## CITY of NOVI CITY COUNCIL

Agenda Item 6  
August 24, 2015

**SUBJECT:** Consideration of a request from Michael and Rachael O'Sullivan for a variance from Section 11-216(e)(8) and Section 11-256(f) of the Design and Construction Standards, which allows a maximum driveway slope of 10% and a maximum sidewalk cross slope of 2%, to allow the applicant to maintain the slopes as-constructed for the construction of a home at 21379 Equestrian Trail (parcel 22-32-401-074).

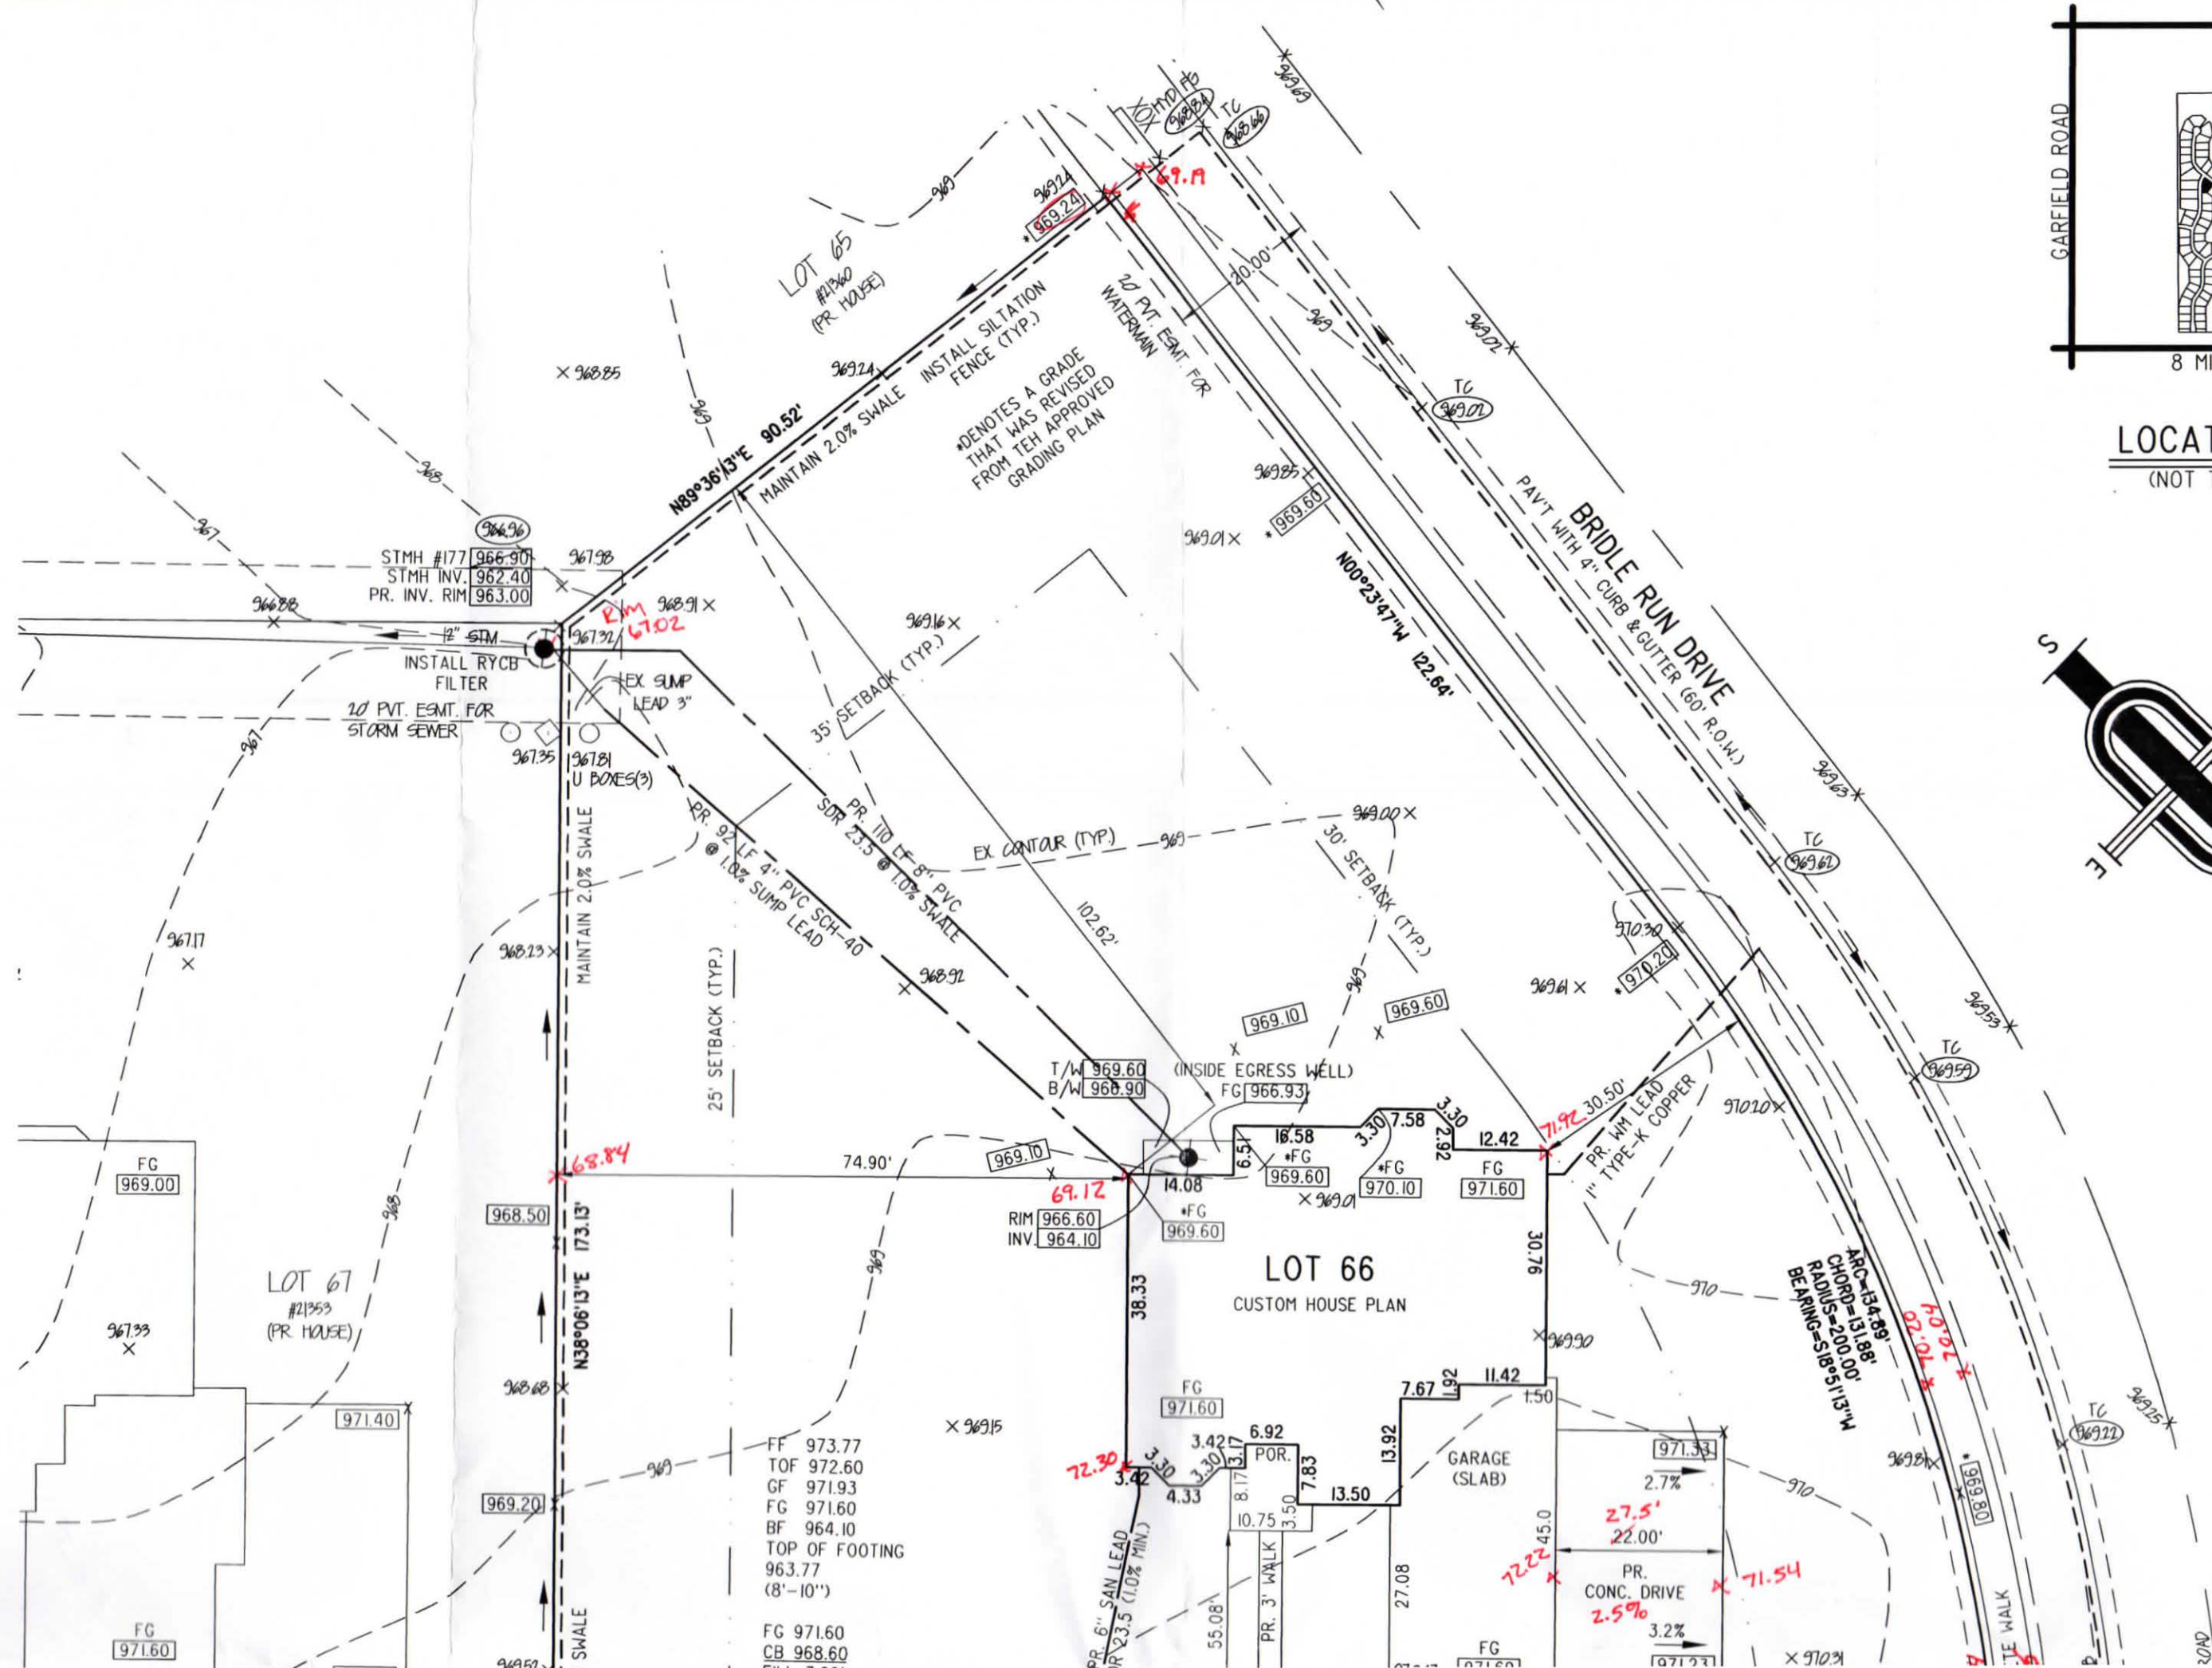
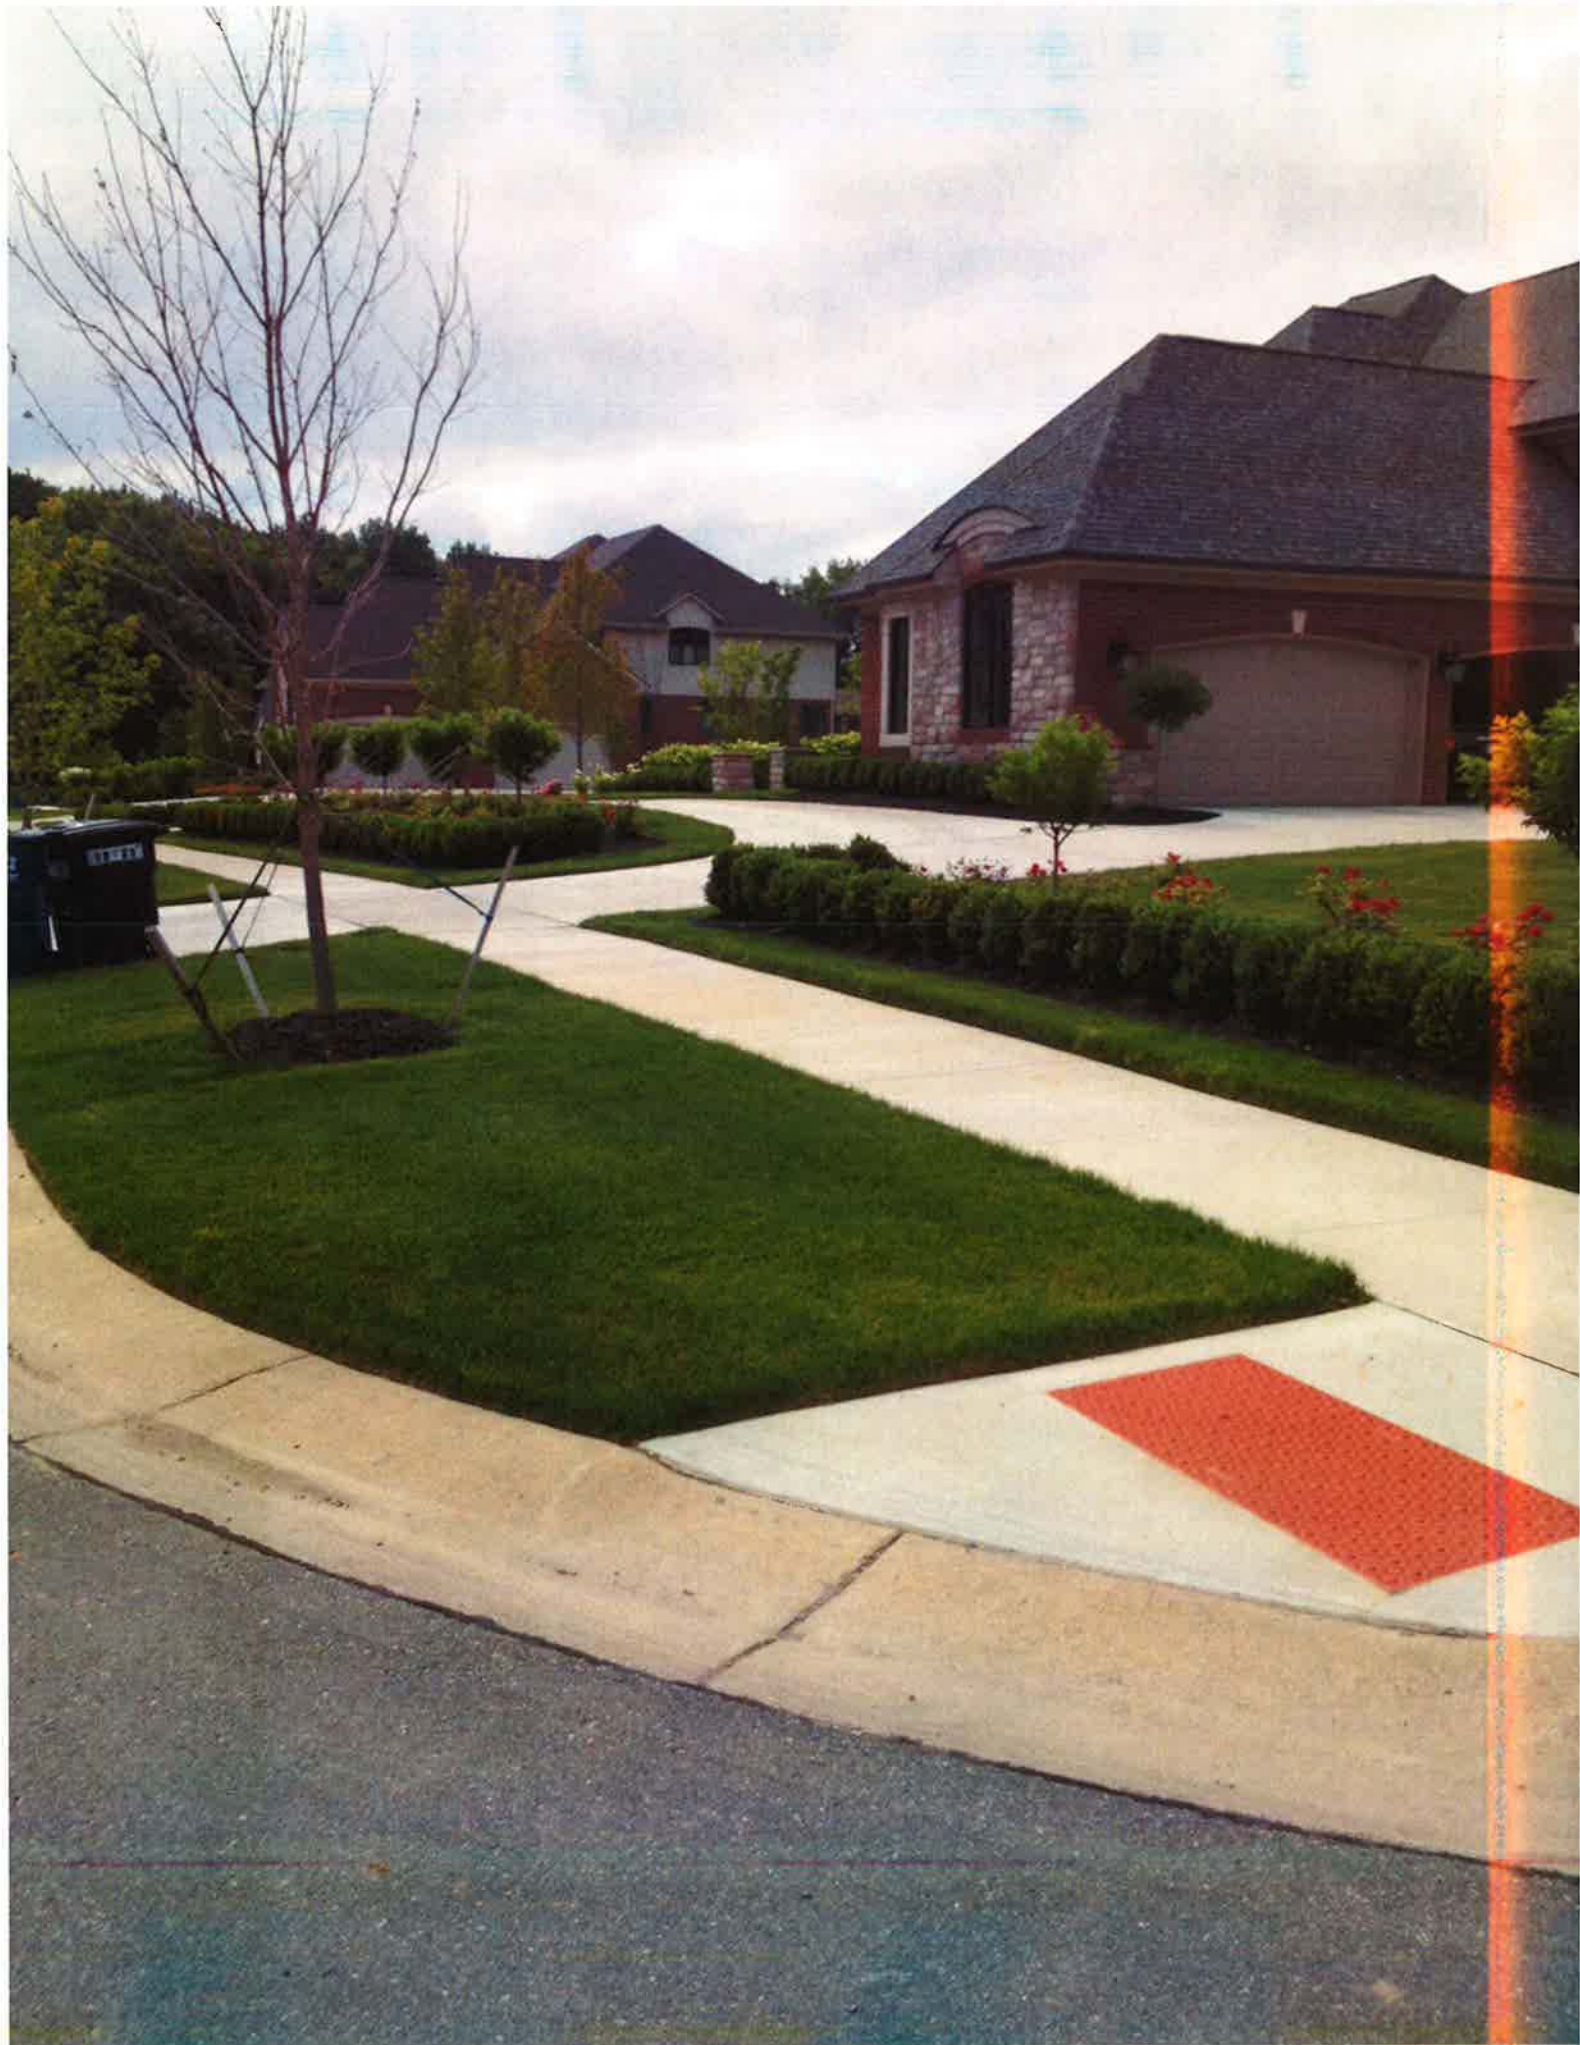
The ordinance sets a maximum running slope for a driveway at 10%, whereas the as-constructed slope on the easterly driveway is 11-14%. The applicant said that they changed the slope in the field because of a manhole that was too low. However, the manhole could have been adjusted to better accommodate the slope shown on the approved plan. Since the driveway is located on private property and the property owner is willing to accept the condition, staff can support this part of the variance request.

The Engineering Design standards set the maximum cross-slope of a sidewalk at 2%, which is consistent with the Federal Americans with Disabilities Act (ADA) Standard, attached. The sidewalk cross slopes as constructed in the field exceed the 2% maximum in more than half the locations measured. Since Equestrian Trail is a private street, it would be the responsibility of the condominium owners to ultimately make the sidewalk cross slope compliant with ADA Standards, not the City. However, the review standard for the variance in Section 11-10 of the ordinance requires that "the granting of the variance will not be detrimental to public health, safety, or welfare..." The federal requirement for the sidewalk cross-slope is primarily intended to protect wheelchair users from becoming unstable. In this situation, the constructed cross slopes of 3-4% could pose a risk to sidewalk users in wheelchairs. The only remedy for the situation is to remove and replace several sections of sidewalk, which would be expensive for the applicant. However, the constructed sidewalk substantially deviates from the standard and poses safety concerns to a segment of the population. For these reasons, staff cannot recommend approval of this part of the variance request.

- Multiple areas of sidewalk + drive are > max allowed slopes (2% for walks; 10% for drives)

- Reference the copy of the red lined plan at the City

Approval of the request from Michael and Rachael O’Sullivan for a variance from Section 11-216(e)(8), which allows a maximum driveway slope of 10% to allow the applicant to maintain the driveway slopes as-constructed for the construction of a home at 21379 Equestrian Trail (parcel 22-32-401-074).

Denial of the request from Michael and Rachael O’Sullivan for a variance Section 11-256(f) of the Design and Construction Standards, which allows a maximum sidewalk cross slope of 2% for the following reasons:
